RFI SK No. 3651

SCALE:-
 NOT TO SCALE
 TITLE
 I.C. DRG. FOR TRIGGER
 DISCAT NO. 1005-003184
 PISTOL AUTO 5mm. - 1A

1995	NAME	DATE
DGN		5/11/95
DRN		
CRD		
APPVD	JWW/100	wm/s
DRG. NO.		
RFI SK No.		3651
SHT-1		10F-1

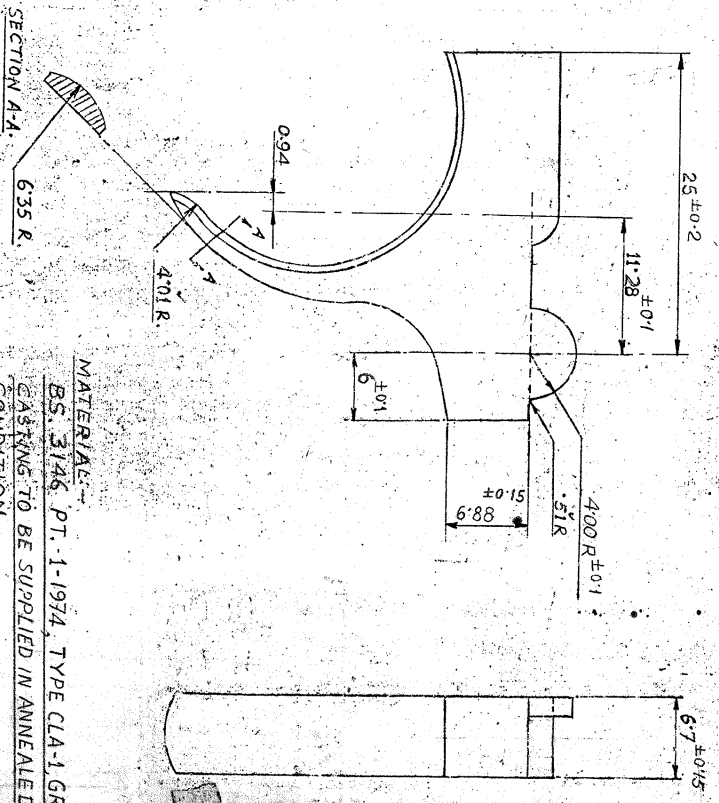
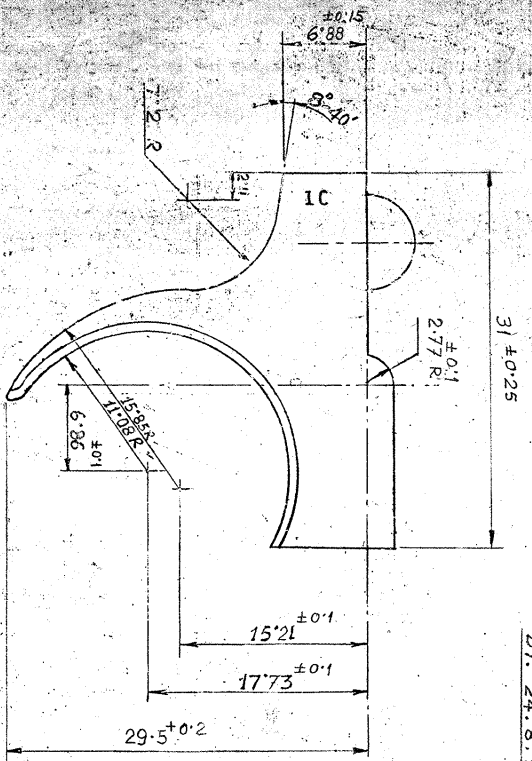
NOTE:- Dimn. 29.5 ±0.2 amended to 29.5 +0.2 as per
 JWW/QC (MVB) Memo:- QC(M)/Tech/97/A-51 *3
 dt. 2.6.97. Hence, Dtg. No. advanced to 3651.
